Subject: Taillem Bend Solar Project Stage 2 – Amendment to Development Application

Overview of Amendment – Technology and Capacity

Appendix C. Summary of Resultant Changes to the Development Application and Appendices

Figure 1 Schematic showing proposed solar module technology

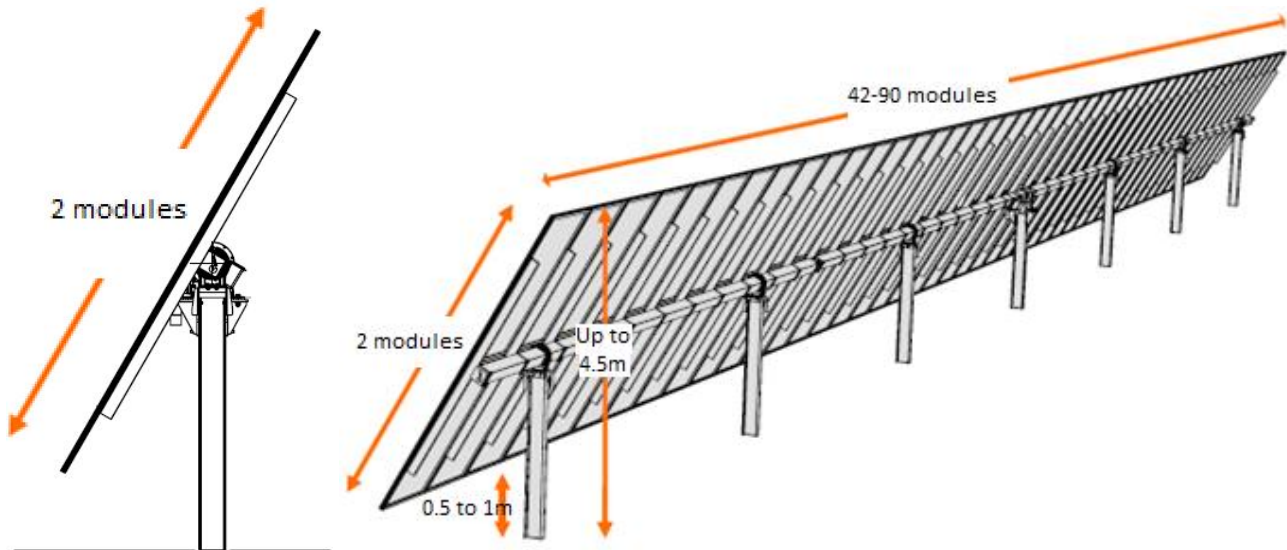
The technology of single-axis tracking is to remain as originally proposed. However, the number of modules per tracking structure may increase from 1 row to 2 rows in portrait (see Figure 1). The final determination of the technology will be dependent on availability, market power and realistic commercial testing during final detailed design. This additional allowance will further provide an increase in overall height from 3m to 4.5m from ground level. An updated tracker design is provided as Appendix A.

Appendix A. Updated Solar Module Design and Indicative Project Layout

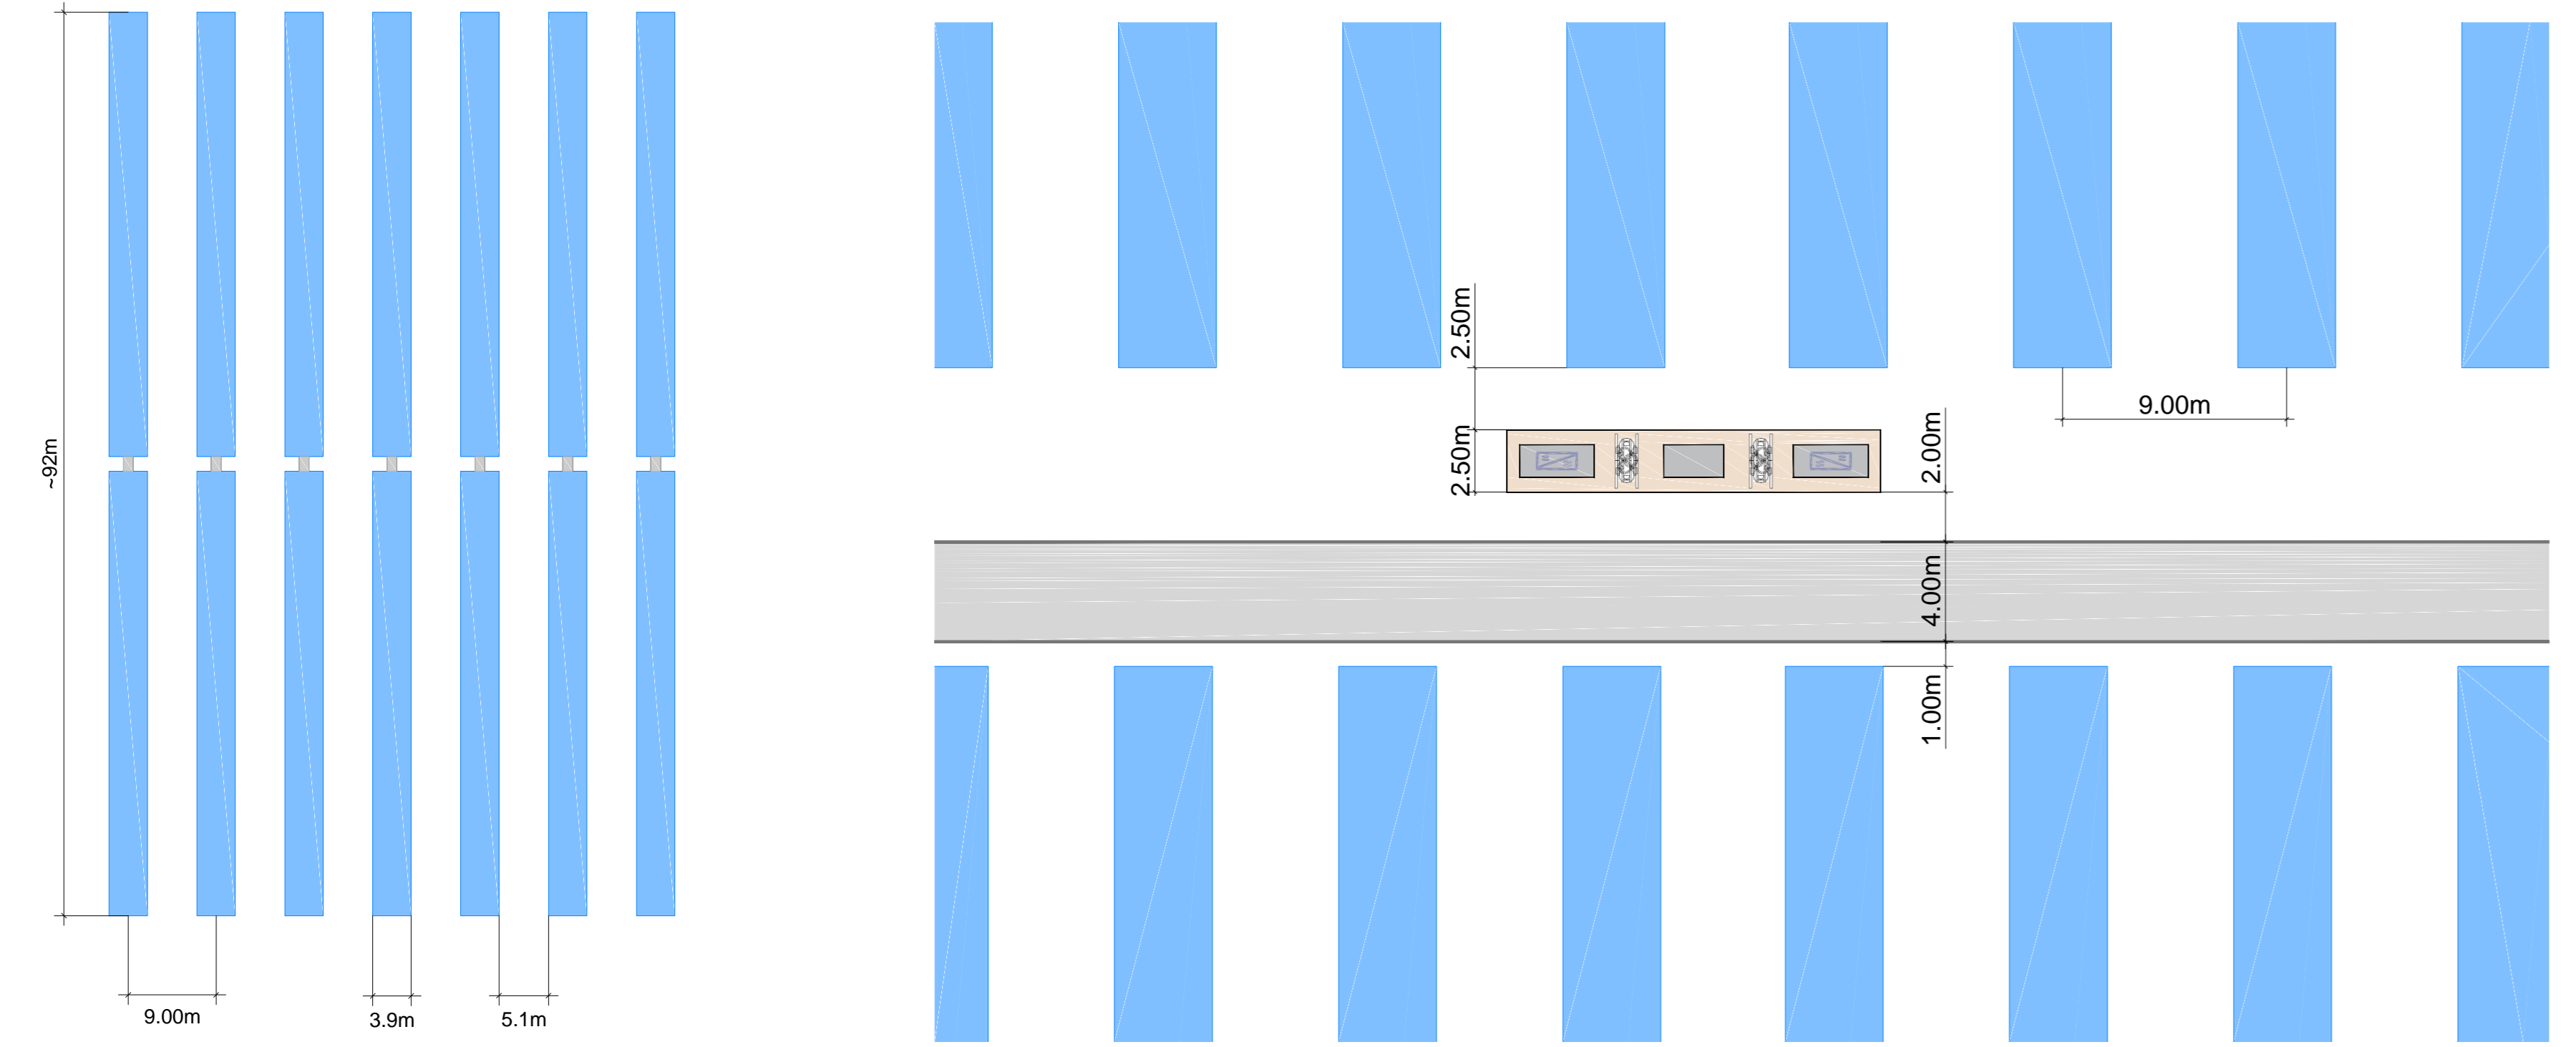
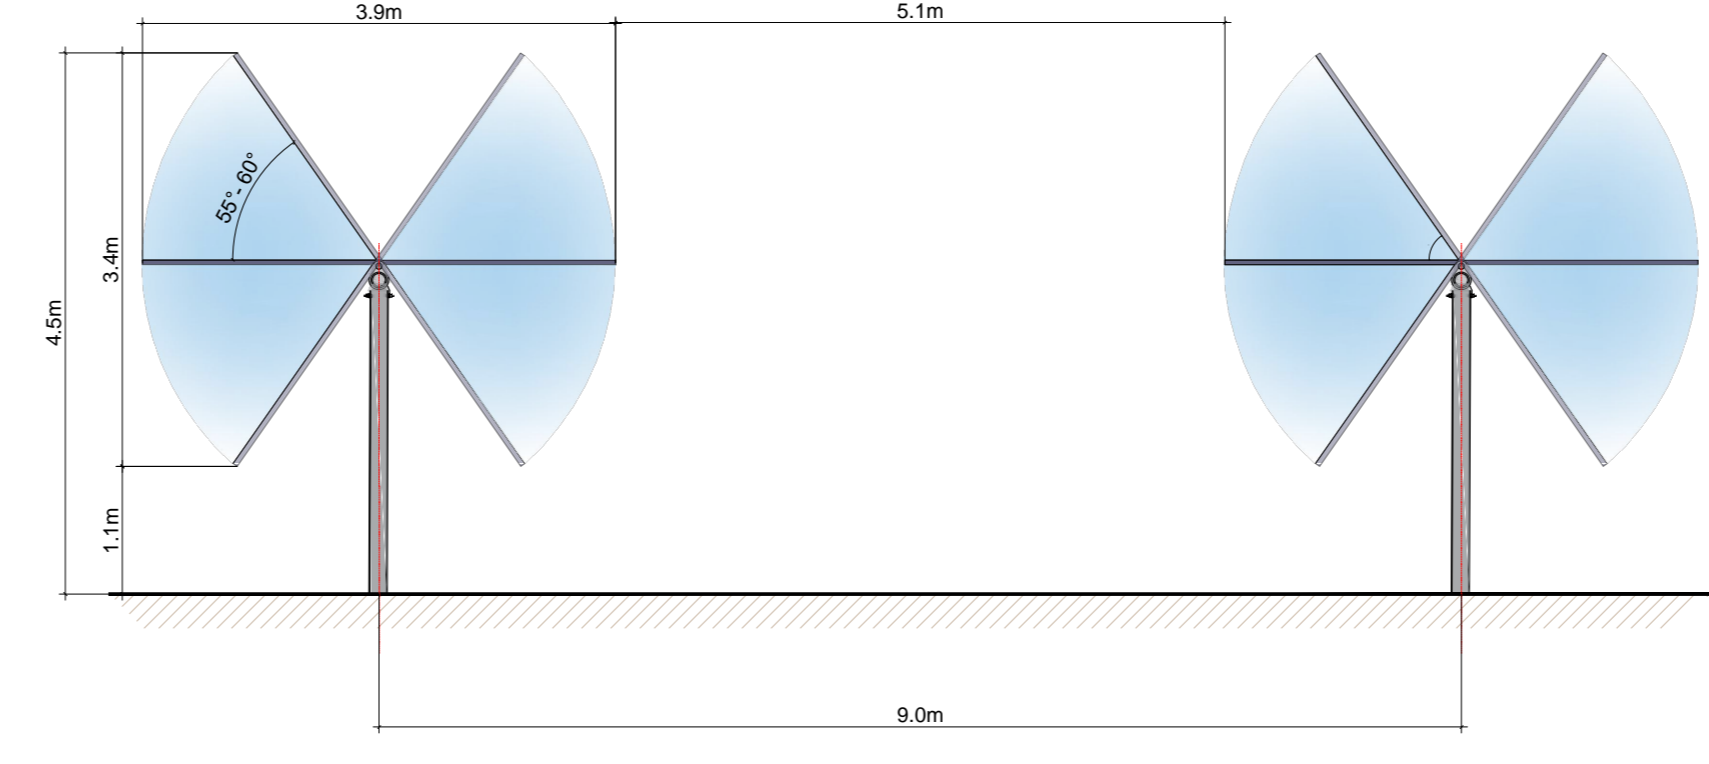
Development Application Section Reference	Summary Resultant Change to Development Application
	<p>to a maximum height of 4.5 metres above ground level.</p> <p>The spacing between the solar panels has changed from approximately 4.5 metres between installation centres to a maximum (worst case) of 9.5 metres spacing between installation centres.</p> <p>The indicative design details shown in Figure 5-2 and Figure 5-3 have changed. The updated design details are presented in Appendix A of this letter.</p>

Tracker Detail
2V90: 2 racks with 2x45 Modules in Portrait / 2V60: 2 racks with 2x30 Modules in Portrait
180 Modules per row (63 kWp) / 120 Modules per row (42 kWp)
6 strings per tracker / 4 strings per tracker
Tilt: from -60° to +60°
